UNITED STATES PATENT AND TRADEMARK OFFICE

APPLICATION NO.	FILING DATE	FIRST NAMED INVENTOR	ATTORNEY DOCKET NO.	CONFIRMATION NO.
09/737,279	12/14/2000	Seiji Hiroshima	MIT:024	7933

Office Action Summary

DETAILED ACTION

Fig. 1

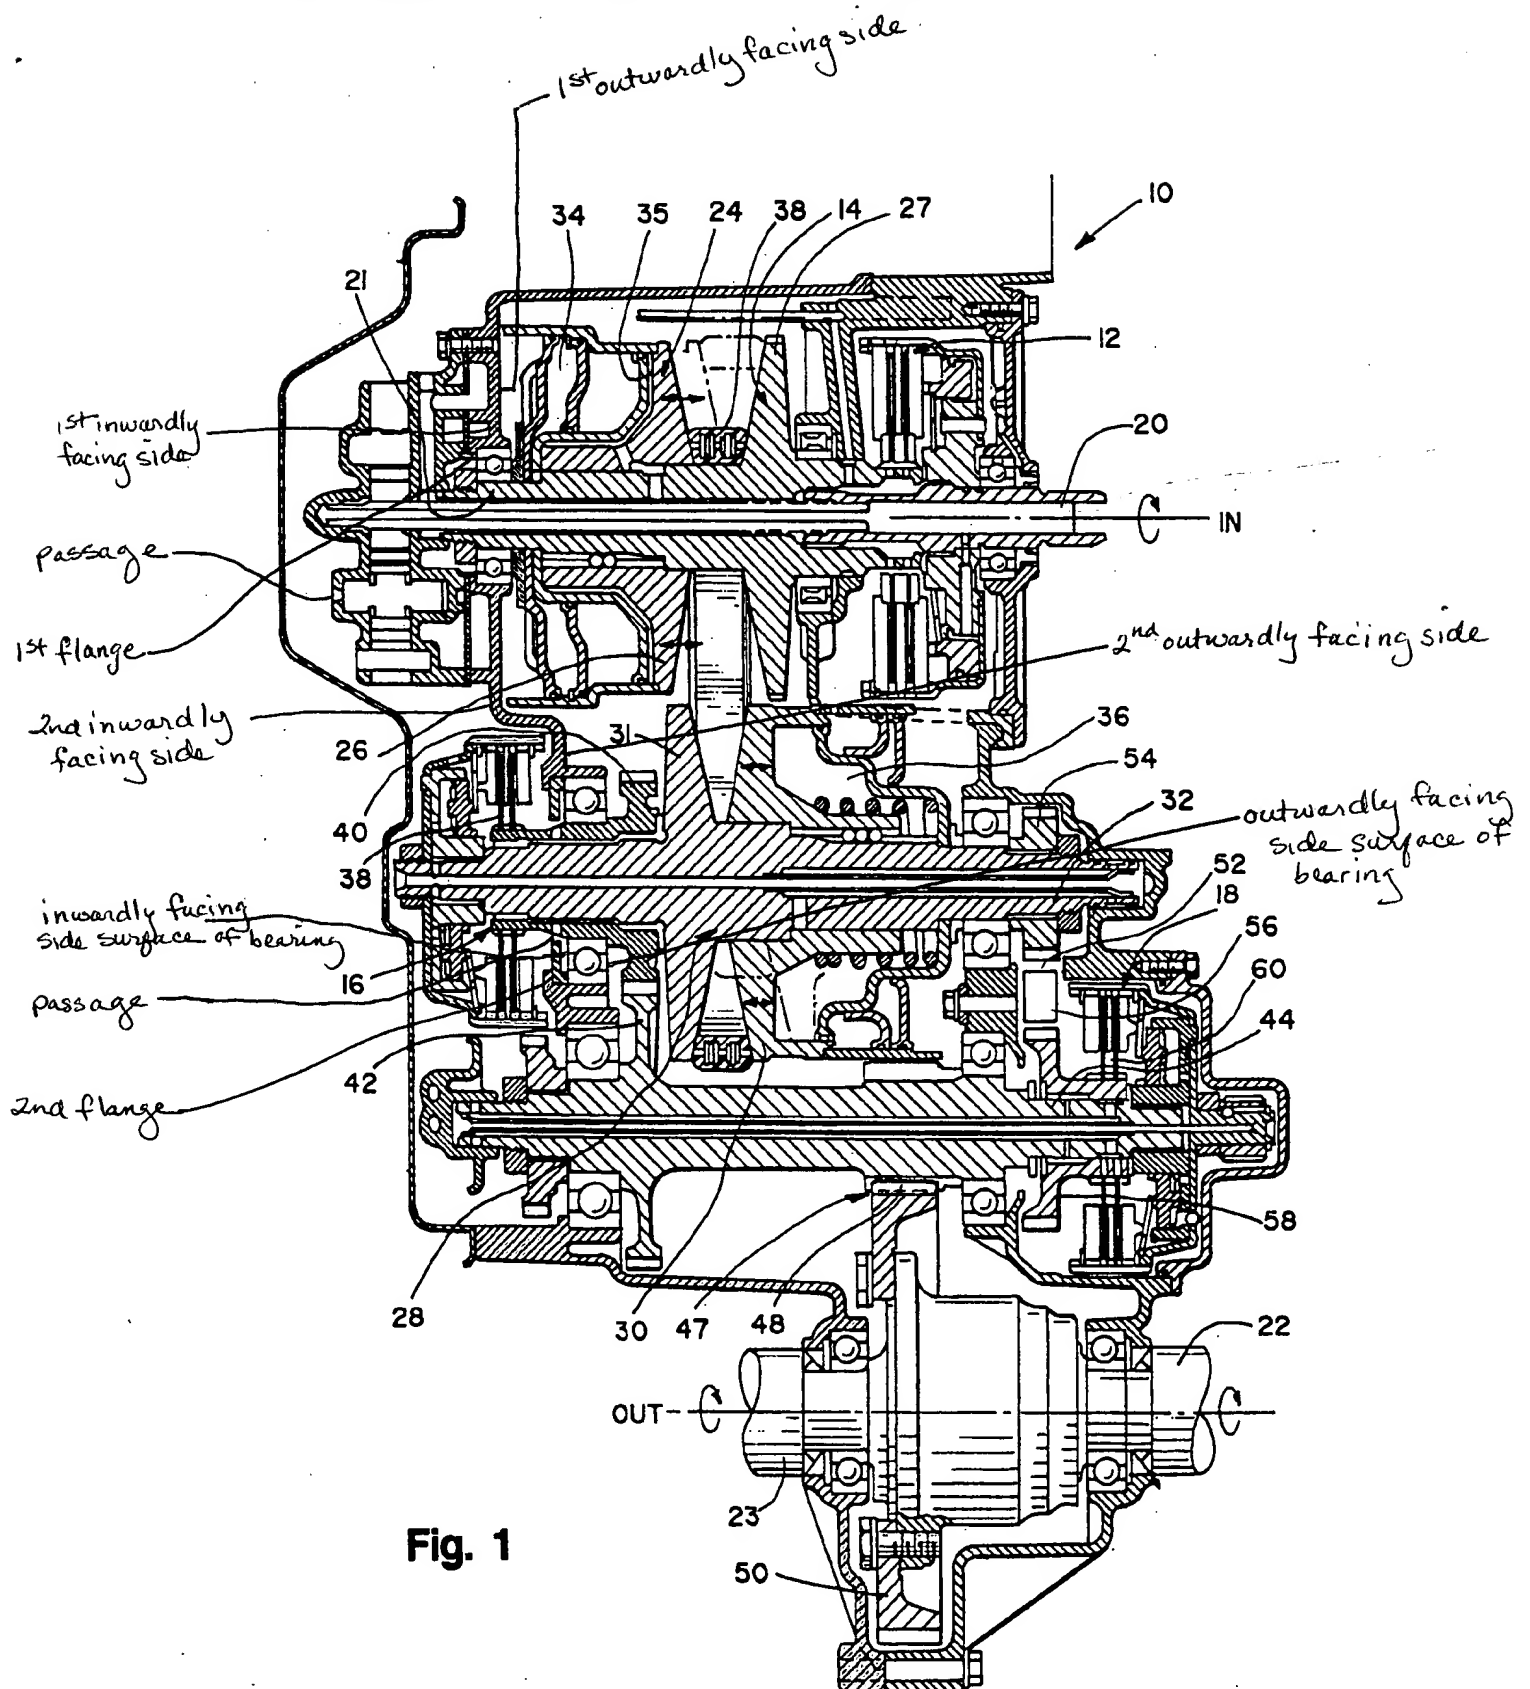
5. Claim 1 is rejected under 35 U.S.C. 102(b) as being anticipated by US Patent 5006092 to Neuman et al. Neuman et al. show in figures 1 and 2 a belt-type continuously variable transmission comprising: a continuously variable transmission mechanism comprising: a primary shaft 20 having a primary pulley 24; a secondary shaft 32 having a secondary pulley 28, and an endless belt 33 wound on the primary pulley and the secondary pulley, a housing (outlined in blue in the attached copy of figure 1) that accommodates the continuously variable transmission mechanism, the housing having an end wall that is formed with a first bearing mounting hole through which one end portion of one 20 of the primary shaft and the secondary shaft penetrates, the end wall having a first outwardly facing side as labeled and a first inwardly facing side as labeled opposite to the first outwardly facing side around the first bearing mounting hole, a first bearing (outlined in yellow in the copy of figure 1) fitted in the first bearing mounting hole and allowing the one shaft 20 to be supported rotatably by the end wall, a flange (indicated by the Examiner in the copy of figure 1) extending radially from the first inwardly facing side toward the first bearing mounting hole, a bearing retainer (outlined in red in the copy of figure 1) provided on the first outwardly

facing side of the end wall and projecting radially inwardly toward the first bearing mounting hole and engaging the first bearing to pinch the first bearing against the first flange as shown, and a first cover (outlined in yellow in the copy of figure 1) that is connected to the housing (at the bottom of the figure 1) and covers the one end portion of the one shaft and the bearing retainer.

Re: claim 7. Neuman et al. show in figure 1 the transmission comprising a second flange as labeled in the attached copy of figure 1, the end wall having a second outwardly facing side as labeled in figure 1 and a second inwardly facing side as labeled in figure 1 opposite to the second outwardly facing side around the second bearing mounting hole wherein the second flange extends radially from the second inwardly facing side toward the second bearing mounting hole, the second cover contacts via the outer side surface of the second bearing (to the same extent as shown in figure 1B of the instant application) the second outwardly facing side of the end wall and an outer side surface of the second bearing in the same plane, the depth of the second bearing mounting hole (which includes the space occupied by the second bearing) which extends in the axial direction is shorter than the combined thickness of the second bearing and the urging member in a free state, which combined thickness extends in the

Neuman et al. show in figure 1 the first and second covers having passages as indicated by Examiner in the copy of figure 1 attached to the Action. In this case the first cover is shaded in orange and is shown to the left of the first bearing shaded in yellow. This first cover is connected to the housing as shown and covers the one end portion of the one shaft and the bearing retainer as shown. Hattori teaches the use of passages 64 and 13d as shown in figure 1 being oil passages through which oil is supplied to the continuously variable transmission mechanism. It would have been obvious to one of ordinary skill in the art at the time the invention was made to have modified the passages of the covers of Neuman, as modified, to have included oil passages, as taught by Hattori, as it is well-known in the art to provide covers with passages in order to provide a means of transporting a working medium, for example, oil throughout the mechanism for lubricating purposes.

9. Applicant's arguments filed 1/21/03 have been fully considered but they are not persuasive. With respect to the arguments regarding the second cover of Neuman et al. it is noted that the structure shaded in green in the attached copy of figure 1 represents the second cover. When shaft 32 is braked by the engagement of the disks

shown in the area of element number 38, the green shaded structure functions as a connected structure with the left side of the green shaded structure covering the end portion of the shaft and the right side of the green shaded structure engaging the outwardly facing side surface of the second bearing. In another perspective, it is noted that the claim language states that the cover covers "the one end portion of the one shaft" and that the one end portion is the portion of the shaft that penetrates the bearing mounting hole as claimed in lines 7-8 of claim 10. In light of the claim language it is noted that element 40 covers the one end portion (the end or outer periphery of the section of the shaft that penetrates the bearing mounting hole) as shown. The remaining arguments are moot due to the new interpretation including a new labeled version of figure 1 of the Neuman et al. reference.
